Item ID: D350-607-541 Accept ***N900040100*** Setup Start ***NS1***
 Revision ID: Stop ***NS2***
 Item Name: Quick Release Heli-Utility Basket™ Long Version Heavy Duty Lid Squirrel Cheek & Spacepod Compatible
 Start Date: 7/02/14 Start Qty: 1.00 ***1*** Cust Item ID:
 Required Date: 7/14/14 Req'd Qty: 1.00 ***1*** Customer:
 Reference:

DART SERVICE INSTRUCTION

**TO AMEND INSTALLATION INSTRUCTIONS D350-607-3 Rev.D,
INSTALLATION INSTRUCTIONS D350-607-4 Rev. C AND
INSTRUCTIONS FOR CONTINUED AIRWORTHINESS ICA-D350-607 REV. 6**

FIGURE 1: INSTALLATION OF D4775-041 FWD STRUT

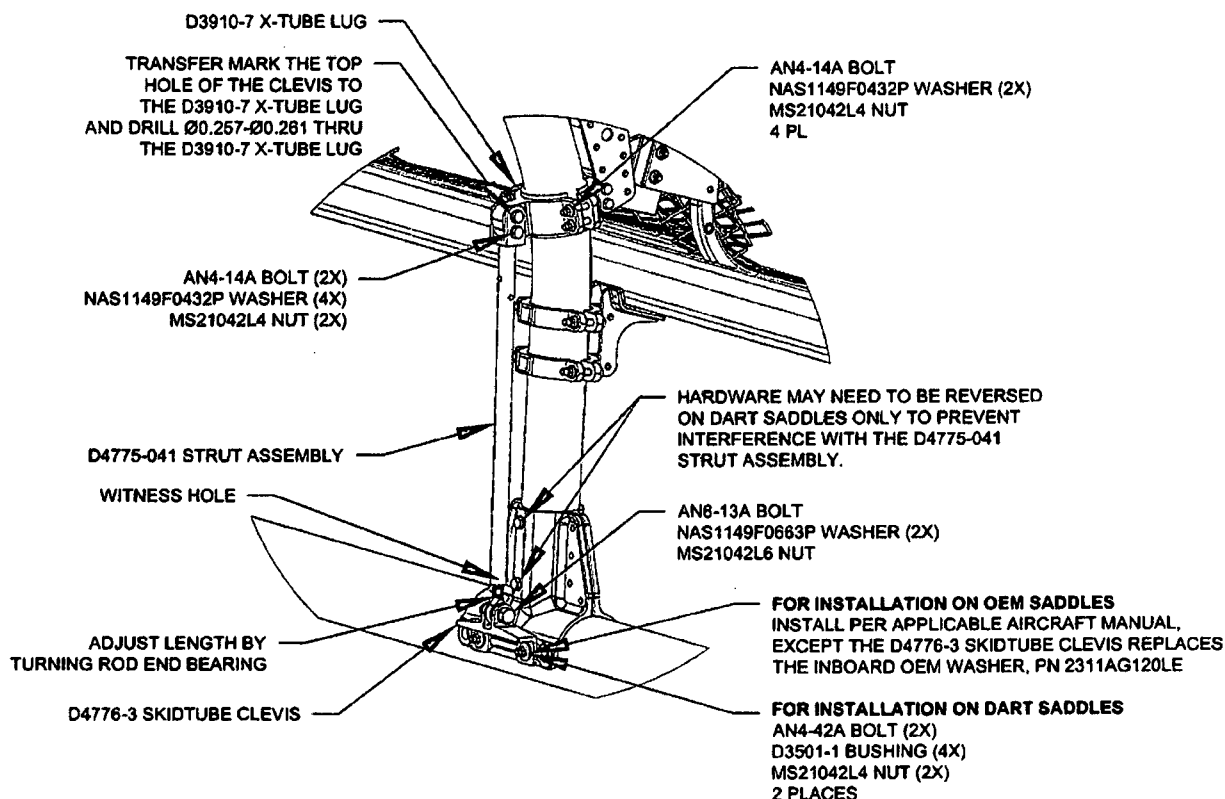
3.1 Substitute the Forward Lower D3910-5 X-Tube Lug with the D3910-7 X-Tube Lug as shown in Figure 1.

3.2 Install the forward D4775-041 Strut Assembly. Transfer mark from the upper hole on the clevis of the D4775-041 Strut Assembly to the D3910-7 X-tube Lug and drill thru the lug $\varnothing 0.257$ - $\varnothing 0.261$ as shown in Figure 1. Touch up chemical conversion coating per MIL-DTL-5541. Check the witness holes located at the bottom end of the D4775-041 Strut Assemblies to ensure that the thread from the rod end extends past the witness hole.
Torque MS21042L4/-4 nuts to 50-70 in-lbs (5.7-7.9 N-m). Torque MS21042L6/-6 nuts to 160-190 in-lbs (18.1-21.5 N-m).
